Addendum No. 2
Naco Pump Station Improvements Project
SAWS Project No. 12-6003
Solicitation No. B-13-021-DD

**SAN ANTONIO WATER SYSTEM
NACO PUMP STATION IMPROVEMENTS PROJECT
SAWS PROJECT NO. 12-6003
SOLICITATION NO. B-13-021-DD
ADDENDUM NO. 2**

December 20, 2013

The purpose of this addendum is to issue a revision to the Contract Documents, plans and specifications for the Naco Pump Station Improvements Project (SAWS Job No. 12-6003).

SERVICE LEVEL 6 (TYP. OF 4)
FLOW METER REMOVAL
DETAIL

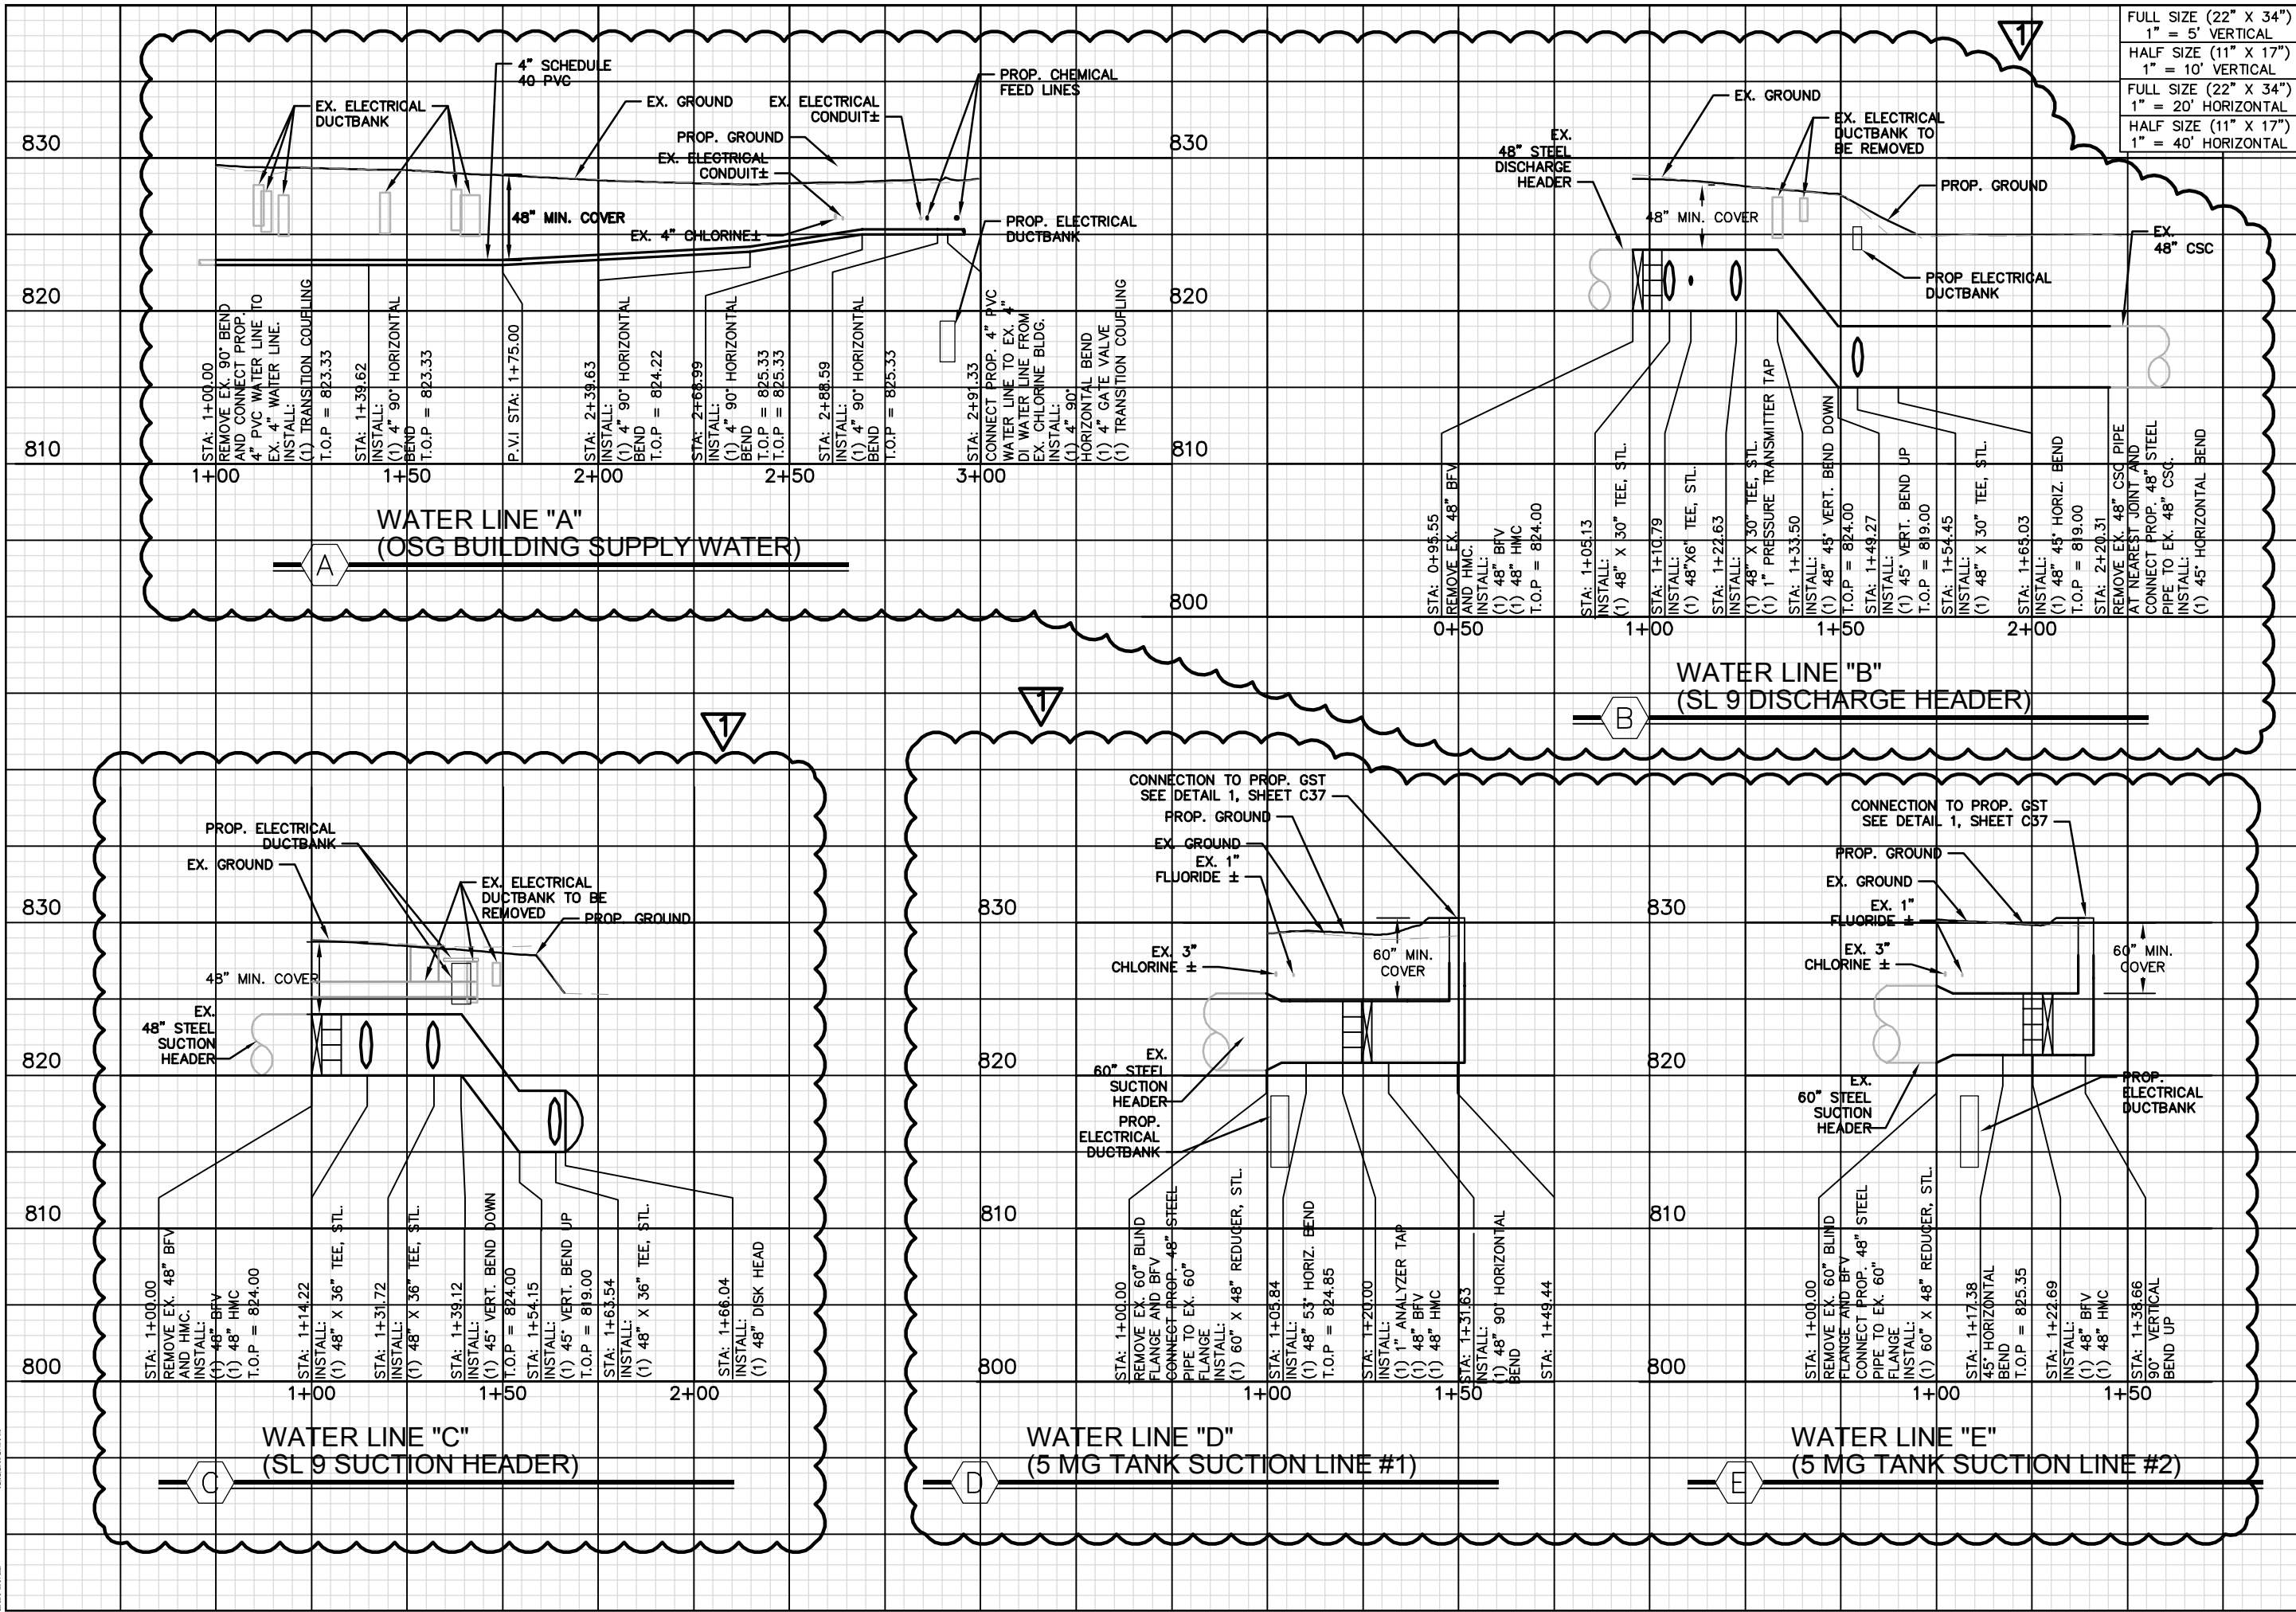
- I. SHEET C8 – CIVIL DEMOLITION PLAN (3 OF 5) – REMOVE Detail 3 and REPLACE with Detail 3 as included with Addendum No. 2.
- J. SHEET C10 – CIVIL DEMOLITION PLAN (5 OF 5) – REMOVE in its entirety Note No. 3 of the Chemical Injection Vault Demolition notes.

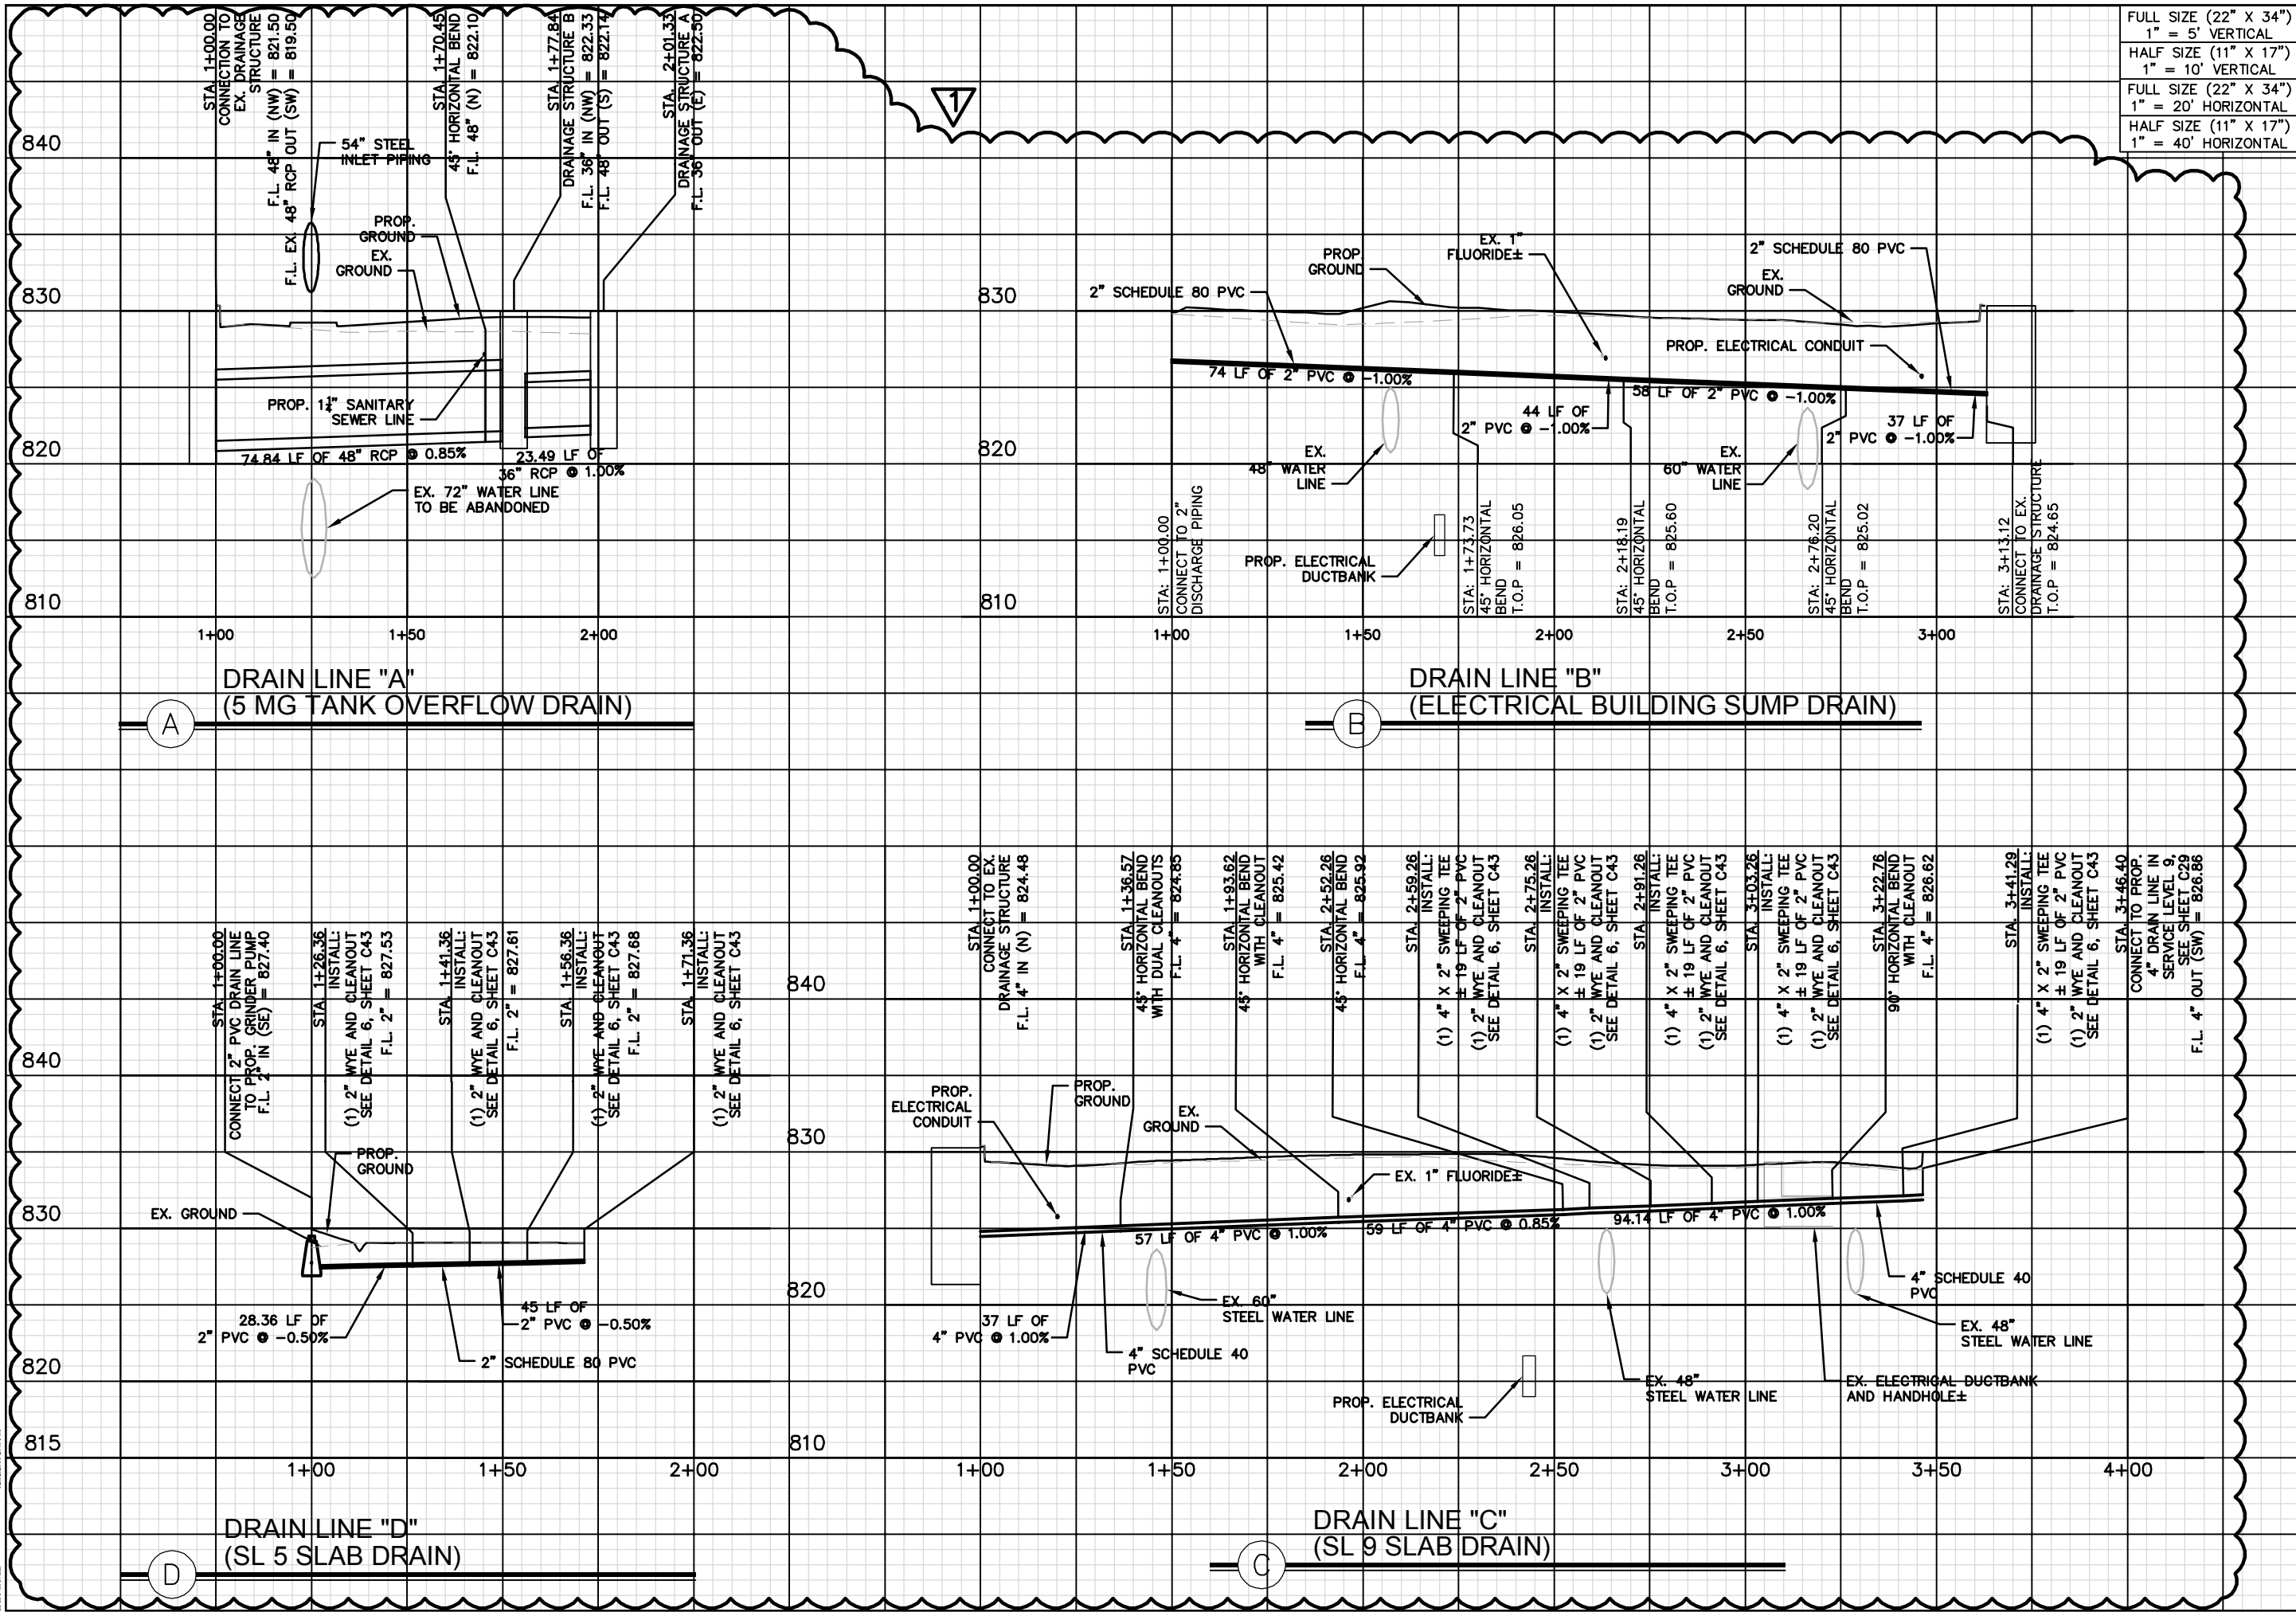
- Q. SHEET C26 – WATER PIPING PROFILES (2 OF 2) – ADD scale to sheet for full size (22" x 34") 1" = 5' Vertical, half size (11" x 17") 1" = 10' Vertical, full size (22" x 34") 1" = 20' Horizontal, and half size (11" x 17") 1" = 40' Horizontal.

ON-SITE GENERATION BUILDING FOUNDATION PLAN & SECTIONS & DETAILS

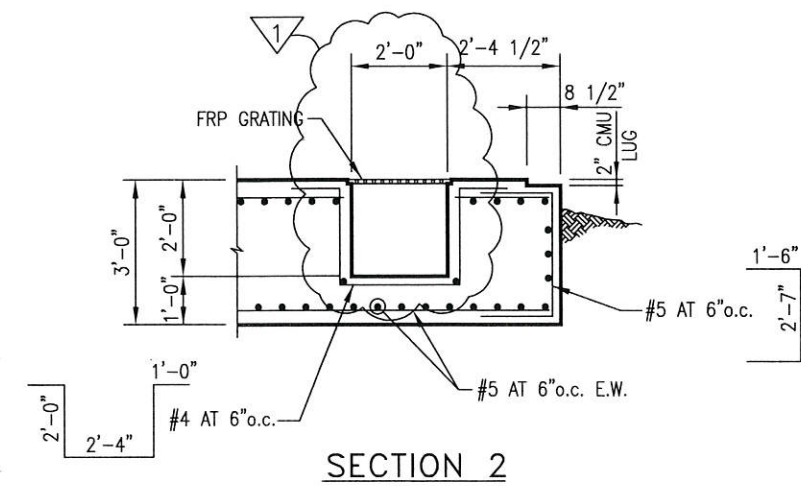
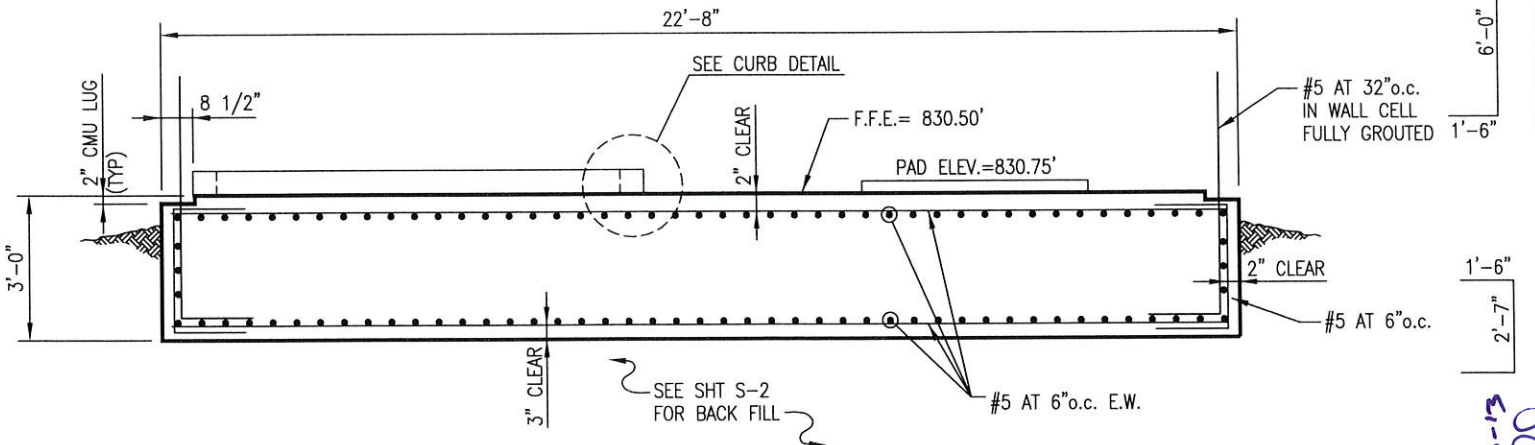
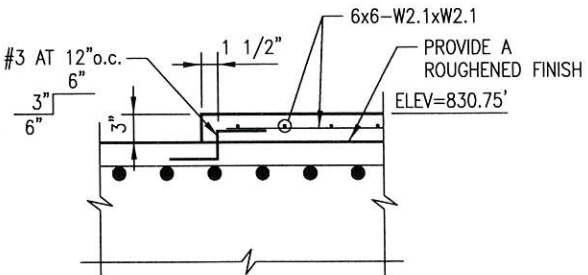
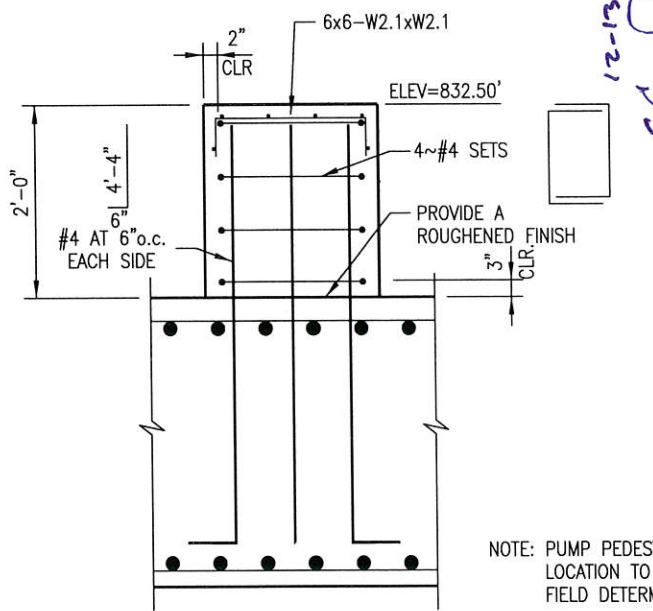
- Sheet S-2A – On-Site Generation Building Foundation Plan & Sections & Details - Removed equipment pad that was located north of the trench, added third pump pedestal & revised trench shown on section 2 to be square, not circular

PROPOSED FLUORIDE BUILDING PLAN

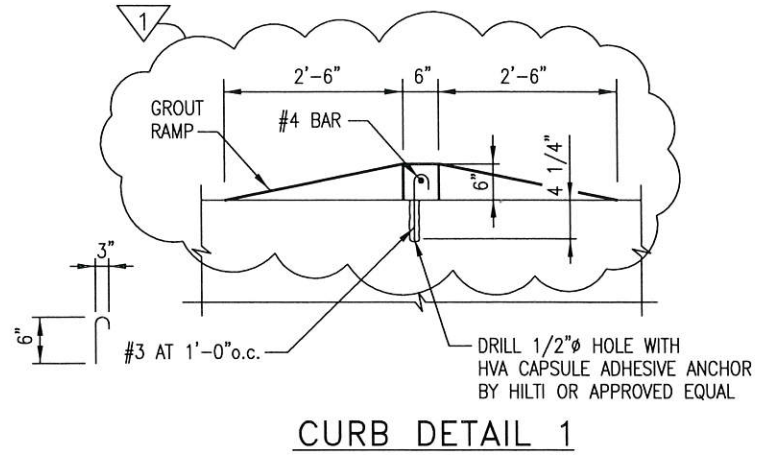
- Sheet S-8 – Proposed Fluoride Building Plan View - Added ramp at proposed curb
- Y. ADD the following Plan Sheet included with Addendum No. 2:

ADDENDA NO.	EXHIBIT NO.
2	BE-CSZ-02

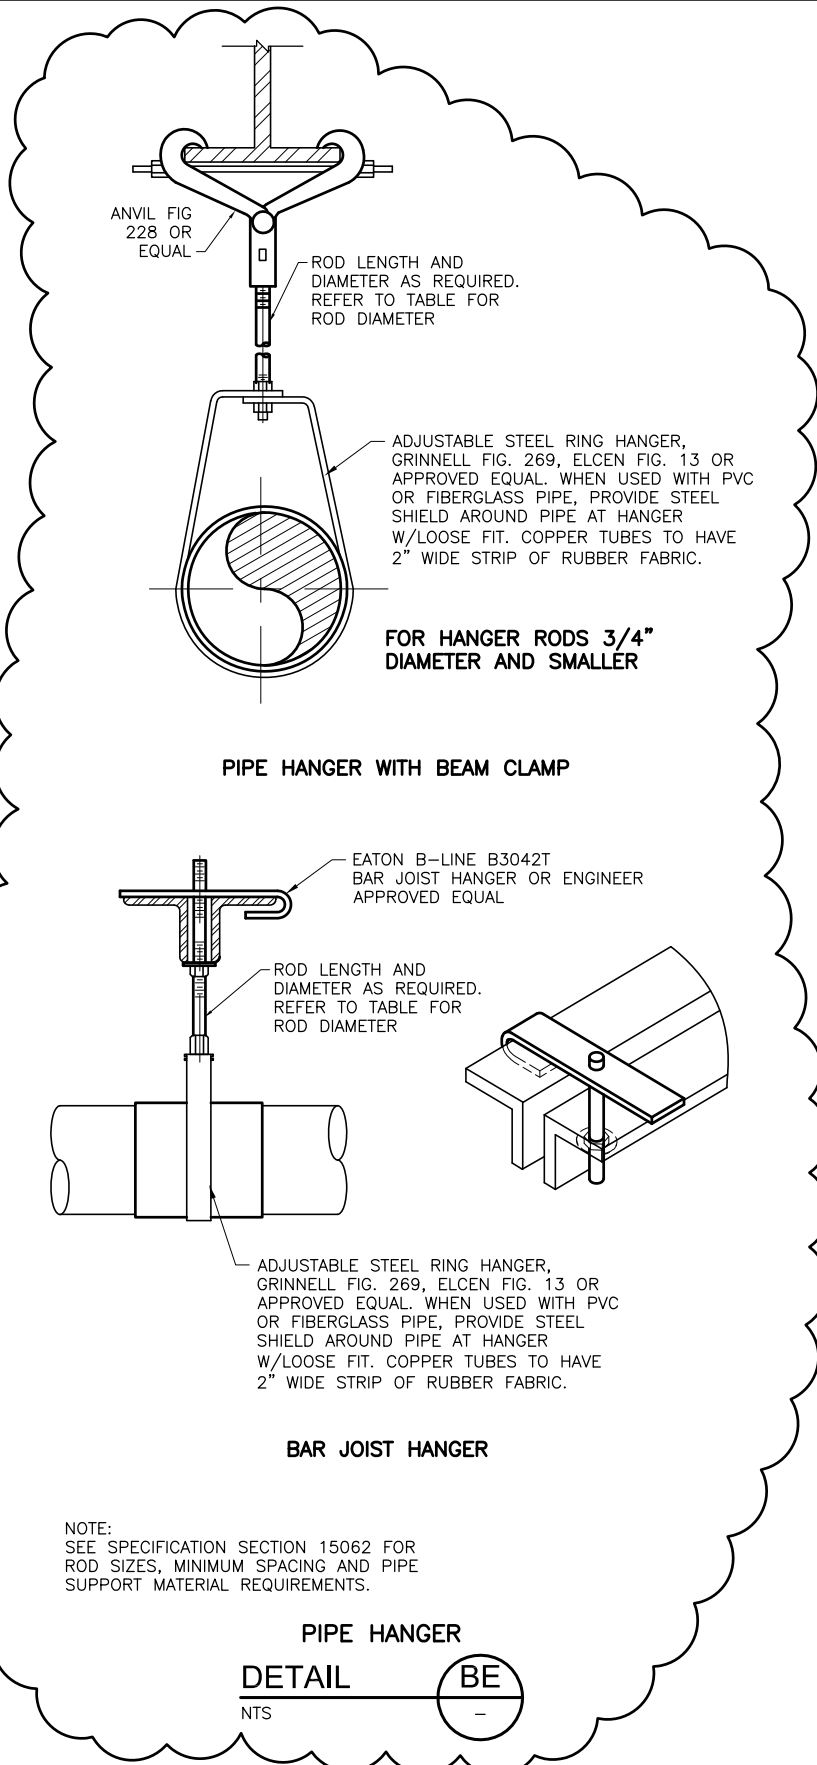
WWW. Sheet CSZ-02 - DELETE Detail BE and REPLACE with that shown in Exhibit BE-CSZ-02.
